ADDENDUM NO. 3

PROJECT: Washtenaw ISD – High Point School
DESCRIPTION: Building Foundations, Structural Steel, Site

BID PACKAGE RELEASE NUMBER: 002

DATE: April 9, 2020			
PROJECT: New High Point School – Wa	ashtenaw Intermediate School District		
TMD DDO IFCT NO . 40040	Mana DDO IECT NO : 4000		
TMP PROJECT NO.: 19040	MaMA PROJECT NO.: 1909		
ADDENDUM NO.: Three (3)	BID PACKAGE NO.: Two (2)

Pre-bid BP 2 - Playground Soft Surfacing Detail Site Work Drawing Clarification

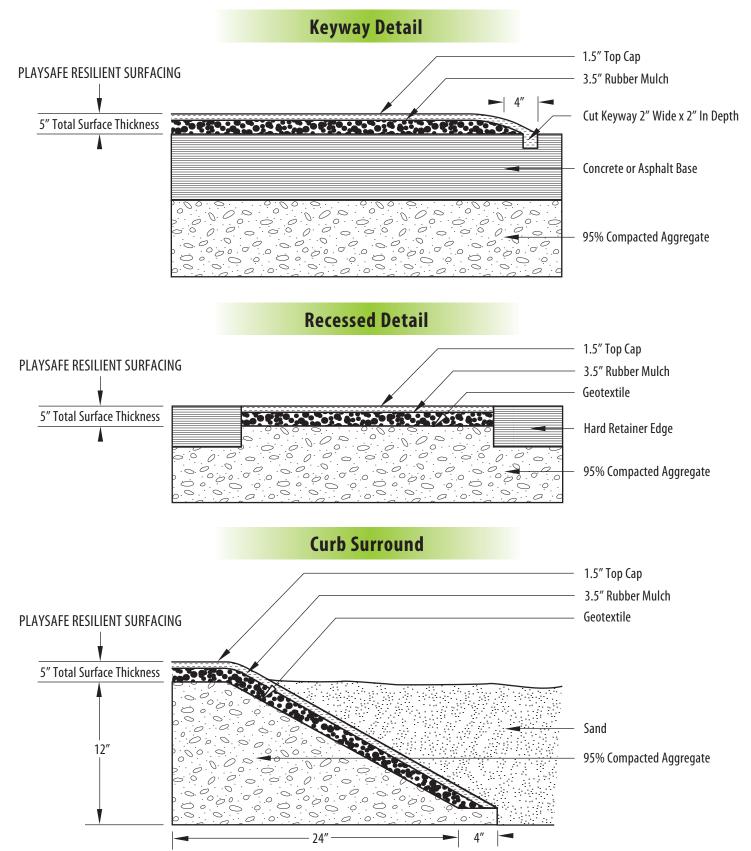
The earthwork associated with the playgrounds for bid pack 2 is to subgrade. Is there a cut of the playground soft surface material available to help determine subgrade?

Playsafer's Recessed Detail is attached. The top of the 6-inch thick crushed 21AA aggregate will be 5-inches below finish grade. The aggregate section will match the On-Site Concrete Playground Cross-Section shown on the Site Details Sheet C7.1.

Pre-bid BP 2 - Synthetic Turf Details Site Work Drawing Clarification

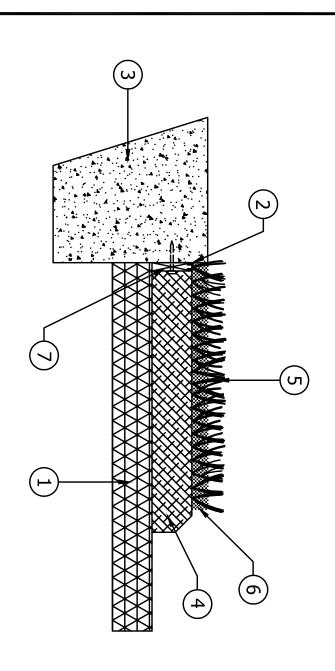
Are there any additional drains (flat drains) and/or aggregates associated with the synthetic turf field? Will this turf have any curb or nailer? If so is there a detail available?

There are no additional drains but there will be 9-inches of aggregate under the two-inch thick Synthetic Turf and Cushion Layer. The bottom of aggregate depth (11-inches below finish grade) will be the same under the turf as it is under the concrete and rubber surfaces. The attached Detail-13 for Synthetic Turf (Nail Board) indicates that the Cushion Layer or Foam Pad will be nailed into the 5-inch thick concrete surrounding the turf field.

S1.1-BP2

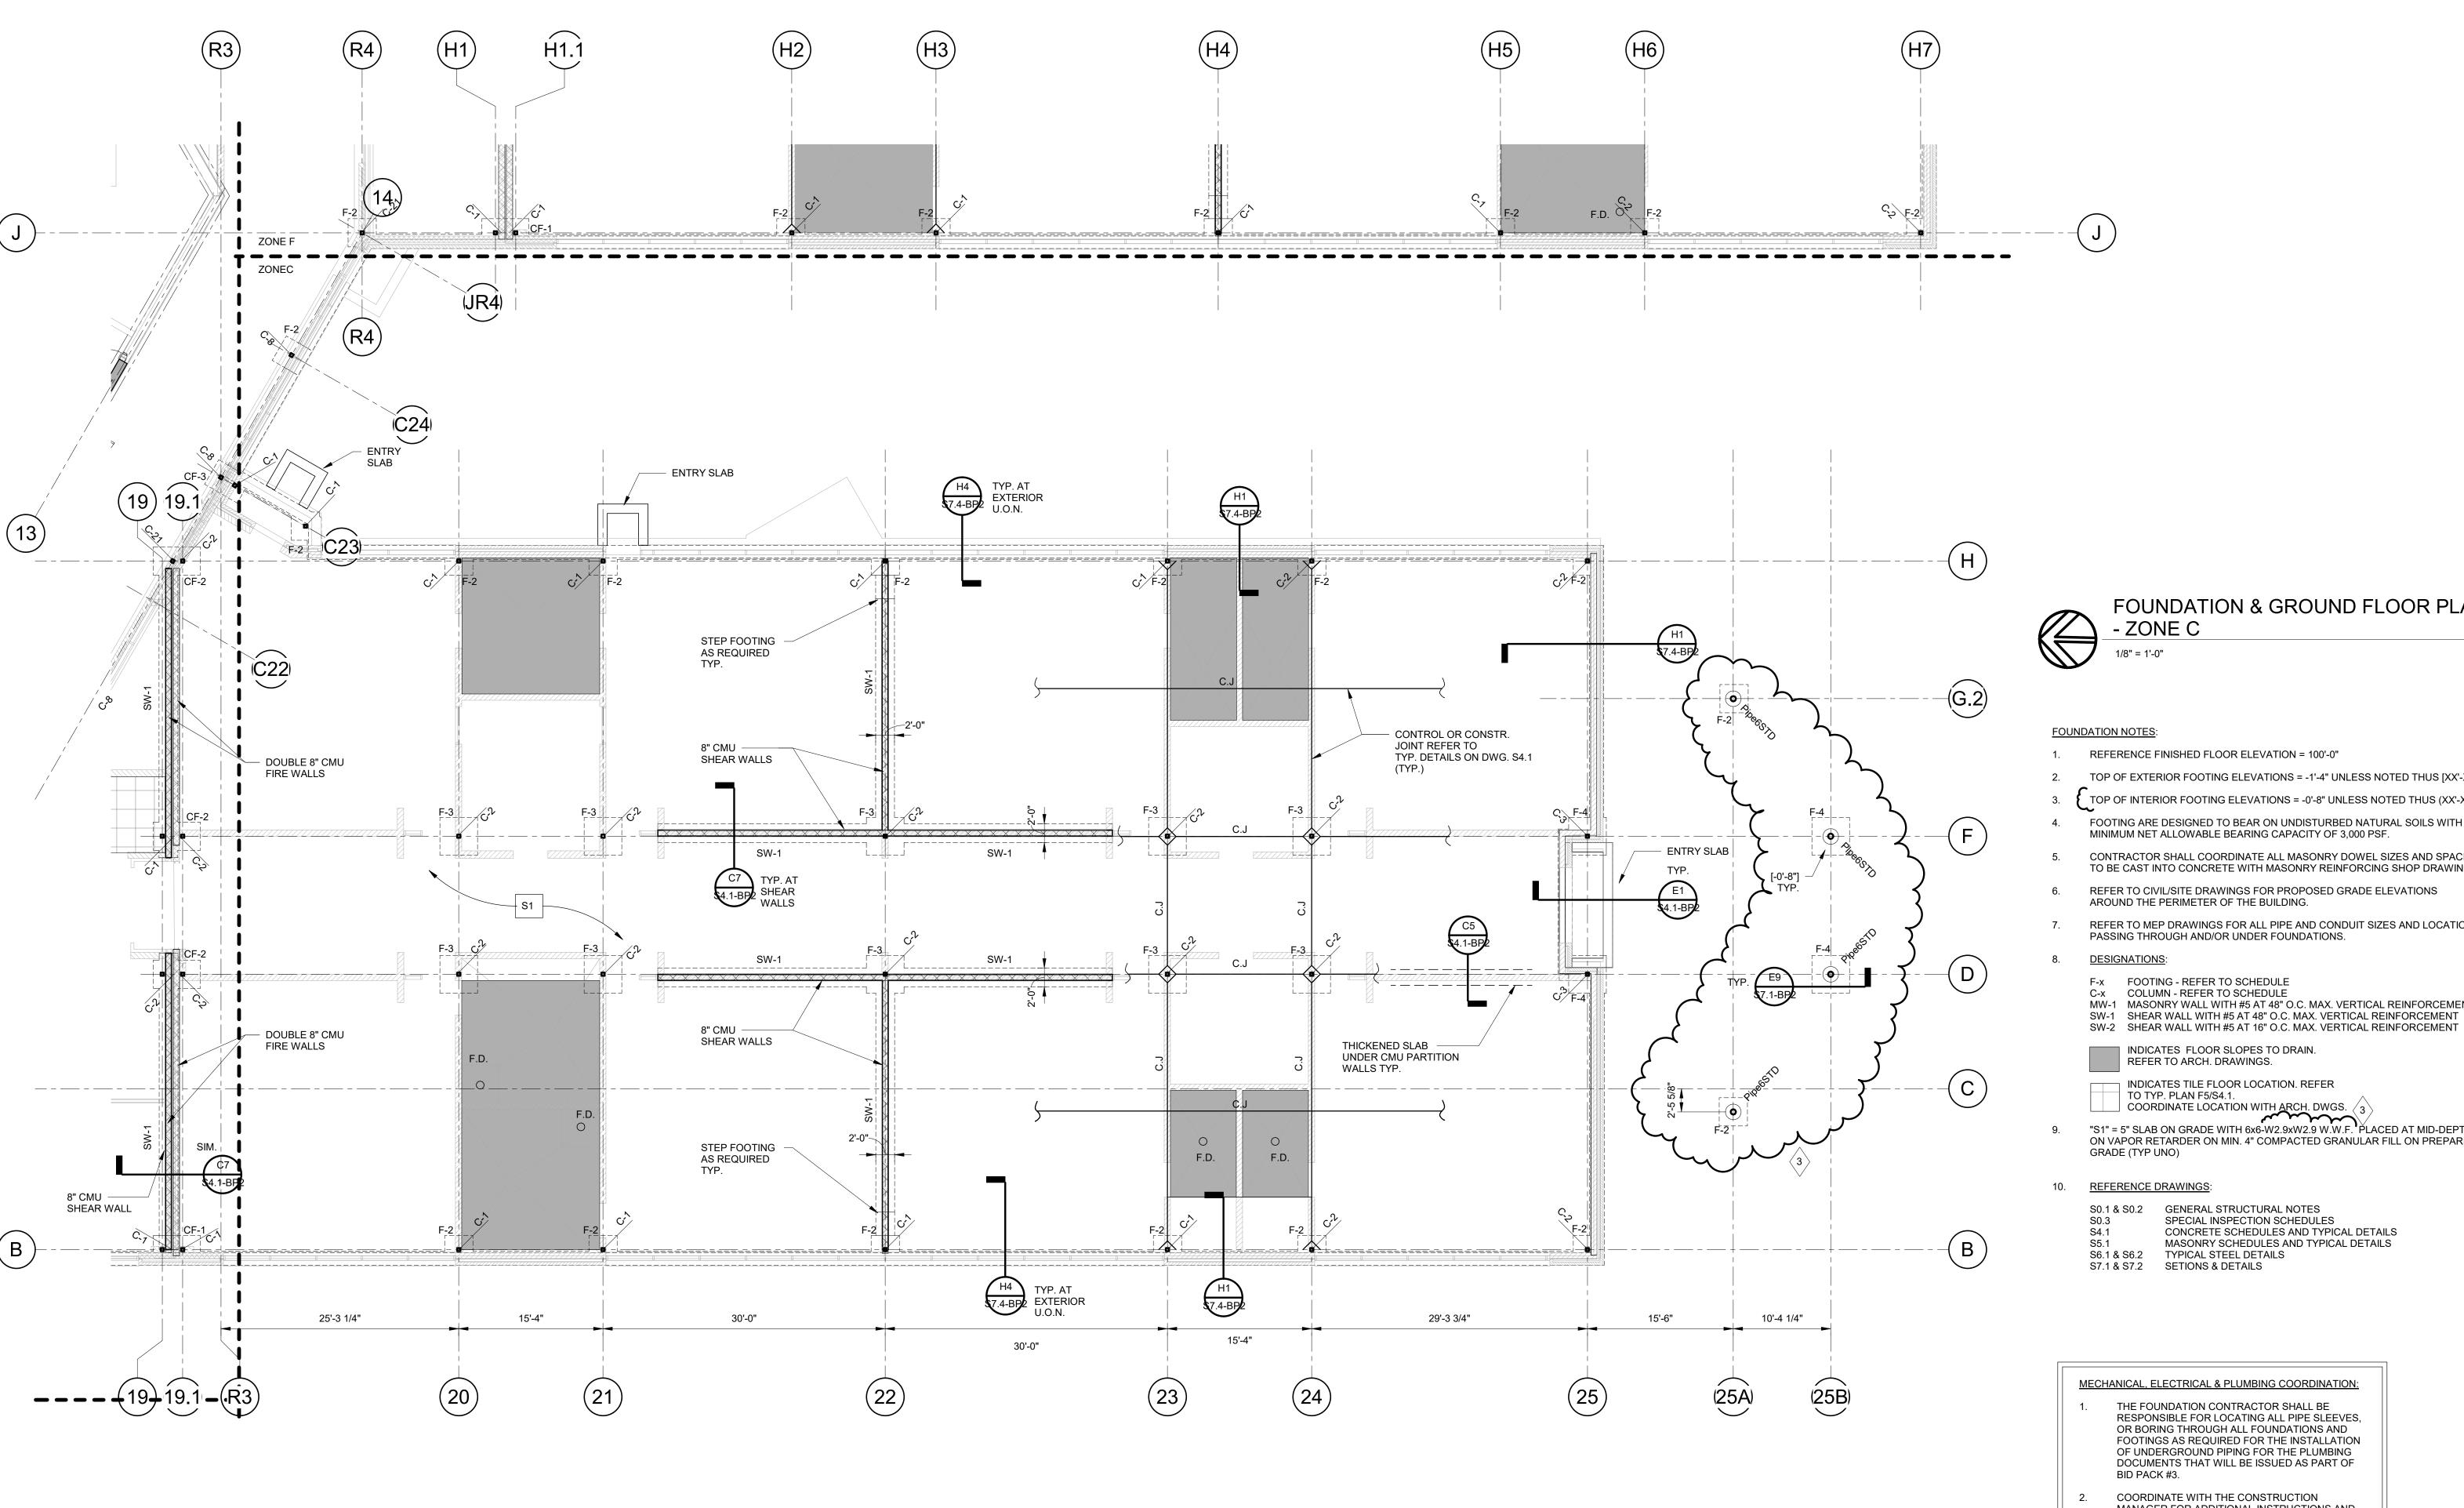
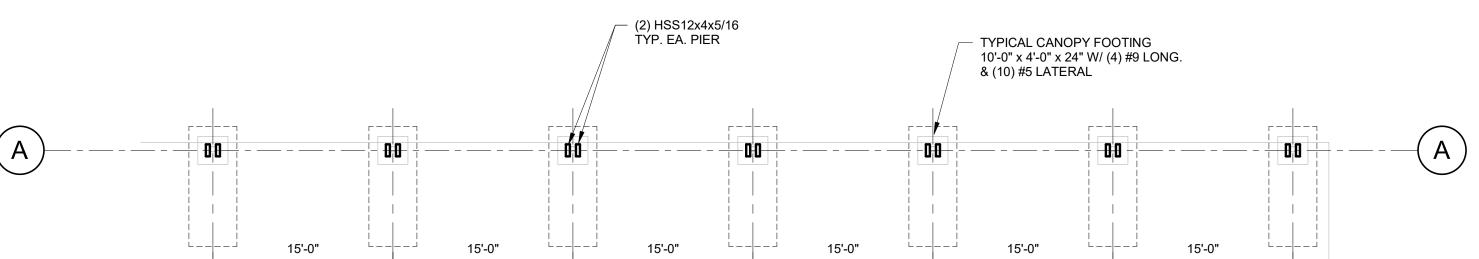
- SD-1 Refer to Drawing No. S1.1-BP2 (reissued):
 - A. At "FOUNDATION NOTES" revised second note #3 to be #9 and revise #9 to be #10. Revised notes #3 and #9 as indicated. Note this revision applies to sheets S1.1-BP2 through S1.10-BP2. Sheets with no other changes not reissued.
 - B. Added brace footing and associated detail as indicated.
- SD-2 Refer to Drawing No. S1.3-BP2 (reissued):
 - A. At "FOUNDATION NOTES" revised second note #3 to be #9 and revise #9 to be #10. Revised notes #3 and #9 as indicated.
 - B. Added dimensions, elevations and detail cut as indicated.

DRAWING NO. S4.1-BP2

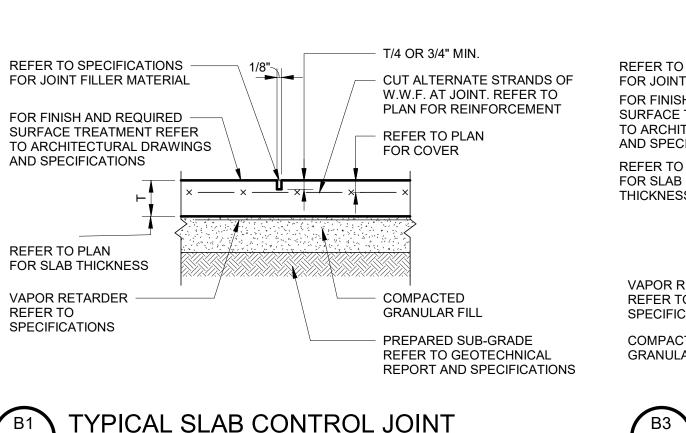
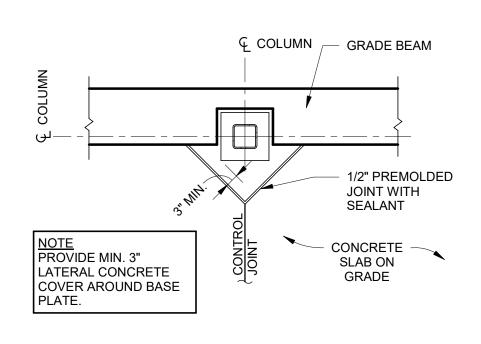
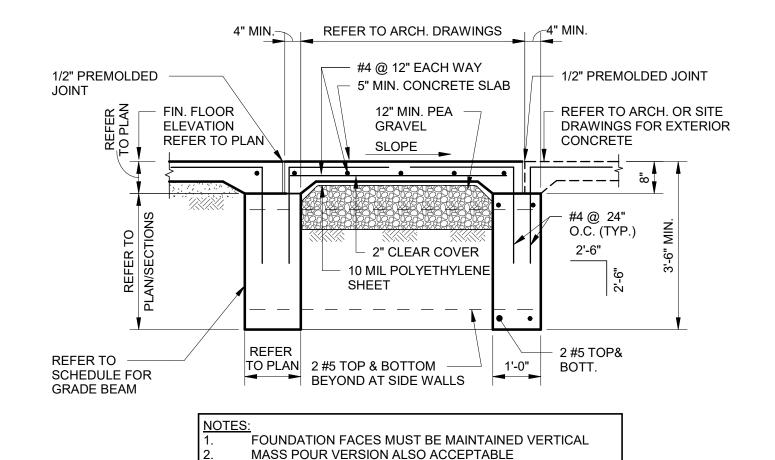
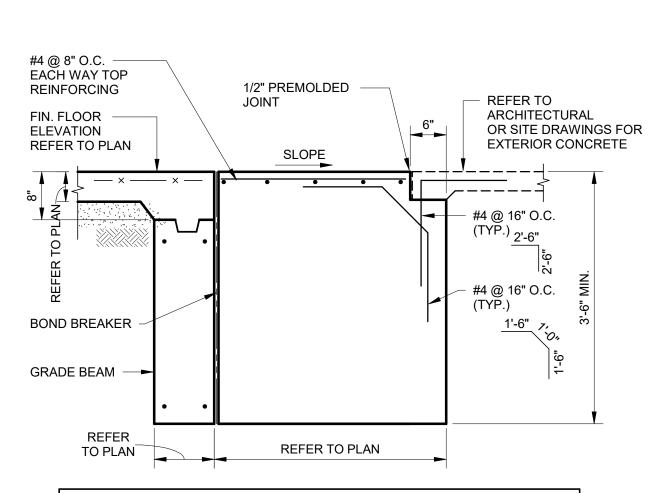
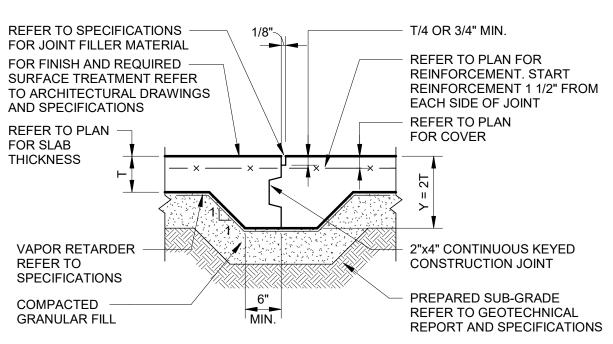
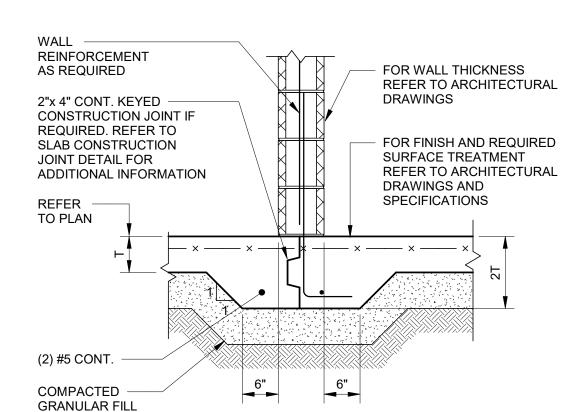
- SD-8 Refer to Drawing No. S4.1-BP2 (reissued):
 - A. Detail C7: Revised dimension of foundation as indicated.
- SD-9 Refer to Drawing No. S7.1-BP2 (reissued):

- * Exterior perimeter footing width = 1'-6" (H1 & H4/S7.4)
- * Interior CMU shear walls footing width = 2'-0" U.O.N. (C7/S4.1)
- * Interior non-shear CMU walls = 1'-8" wide thickened slab (C5/S4.1)
- * Other footing widths per details
